I reviewed your latest plan and noticed that the house footprint, FF & BE were the changes on this plan. On your transmittal you didn't mention any details for the resubmittal, but if I am missing something else please let me know. Also, I wanted to request that you make the changes from the previously approved submittal as I had to hand write those in (see the attached highlighting the changes). Thank you kindly.

BRICKELL PROPERTY
 TAX MAP: 10, GRID: 1,
 PARCEL: 274, ZONED: RR-DEO
 3RD ELECTION DISTRICT
 HOWARD COUNTY, MARYLAND

PERMIT SITE PLAN
LOT 11

RE: 1701 Brickell Way (Lot 11) [Off Mayapple Drive]

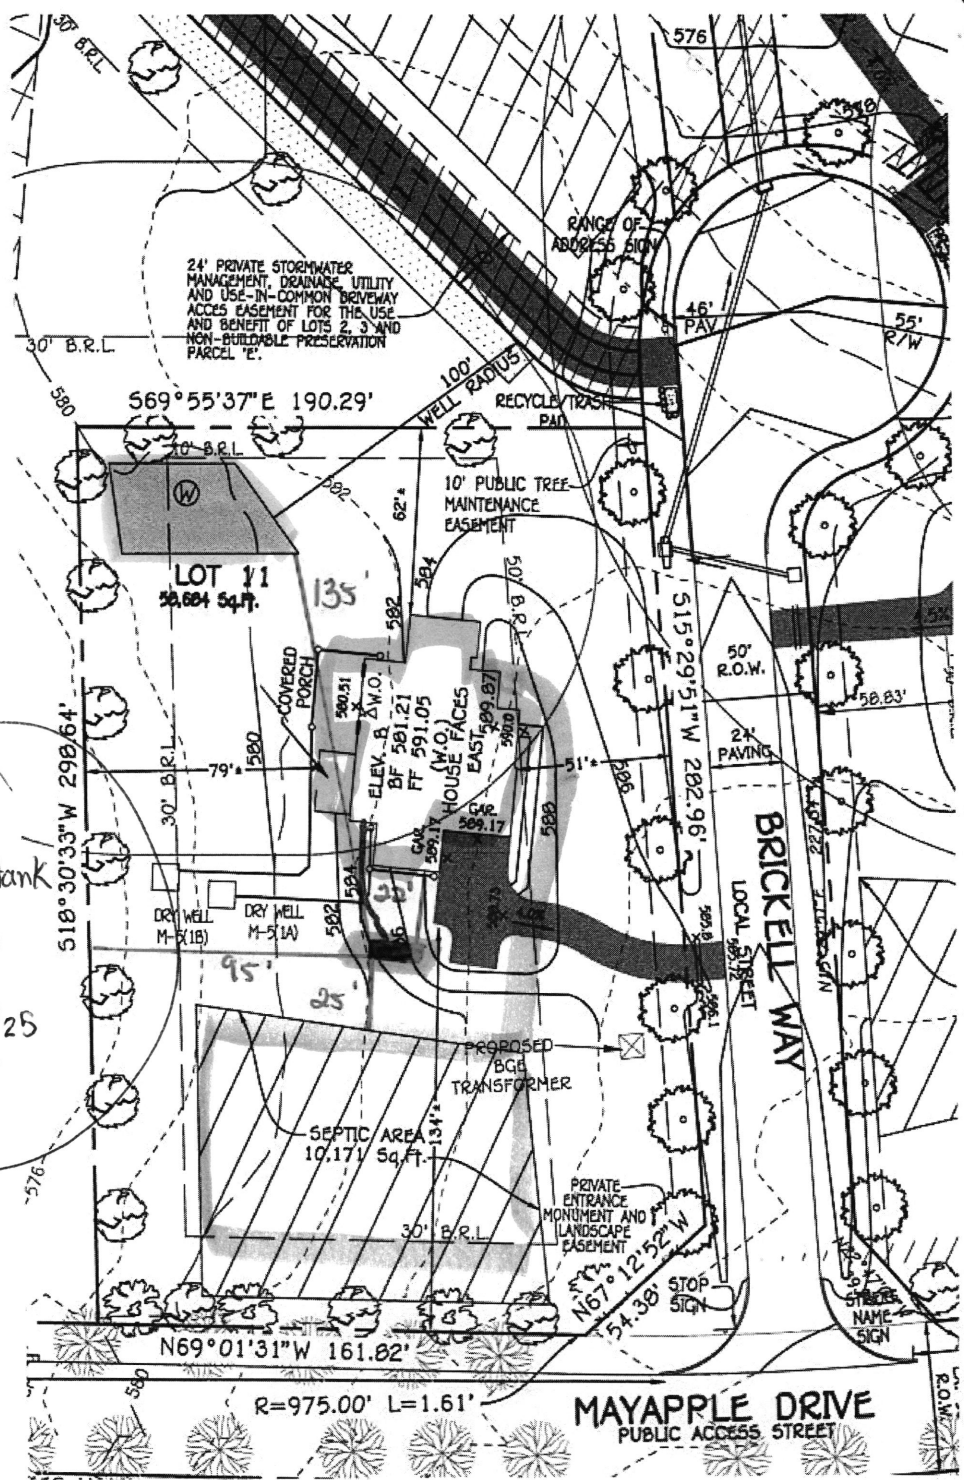
Approved for LP tank
 B2500 4790
 10/30/25

1000 gal w/ei Proposed tank
WELL CERTIFICATION

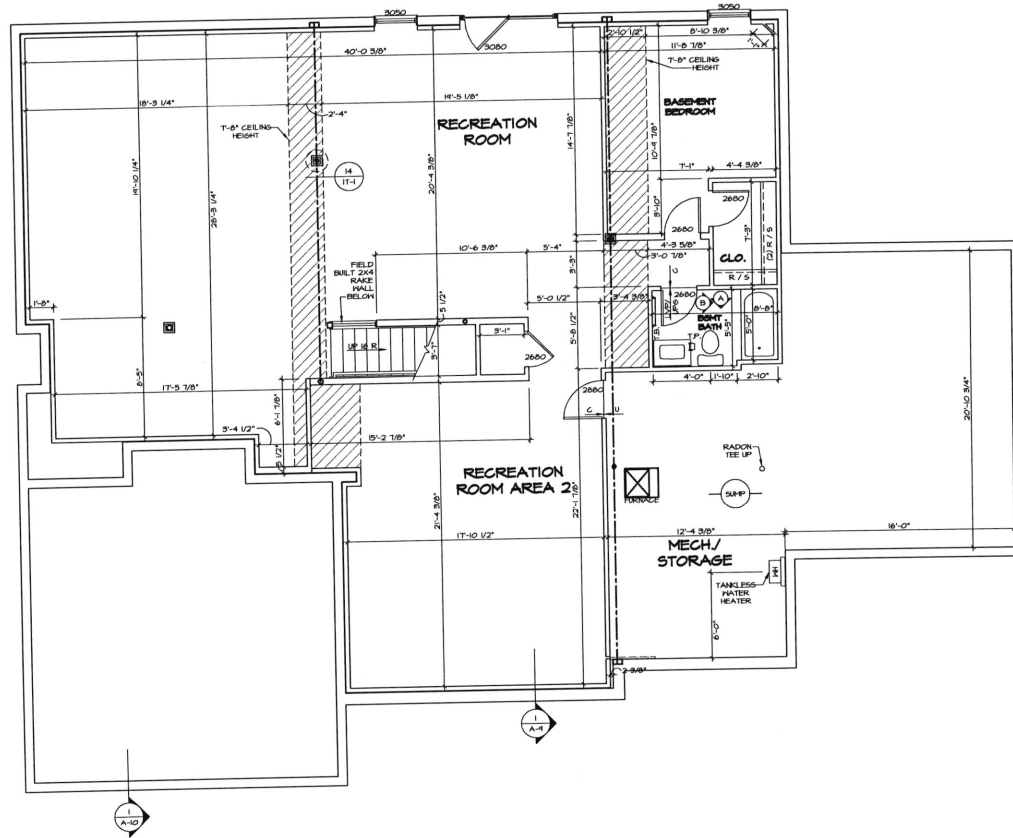
1. It is recommended that the OSDS plan be sized for 7 BDRs.
 - a. Based on a 6 BDR building permit, with only a partial basement finish.
2. We have updated the spec sheet, see 2nd page. This will alter the calculations and trench details.

- a. We will normally cap the amount of sidewall credit given at 4 feet.
3. Label well box square footage.
4. Note #3 not applicable on this project.
5. Missing bearings and distances on property lines.

6. Perc holes and associated elevations should be less invasive on this plan.
 - a. Legible but smaller font.
 - b. Elevation detail smaller than perc number.

7. Add note, "Main septic line from tank to dbox under driveway must be sleeved, see plot plan for details."
8. There was an ECP for this project where a bioretention device was shown in the front yard for this property. If it is still intended to be used, it should be shown on the plans and meet minimum setback distances from well and septic components.

Sorry, we should have had the purpose note – but yes the Builder wanted to make sure there was not an issue with the Foundation Plan provided with the Septic Permit.

We will also correct the trench specs to match the hand changes.
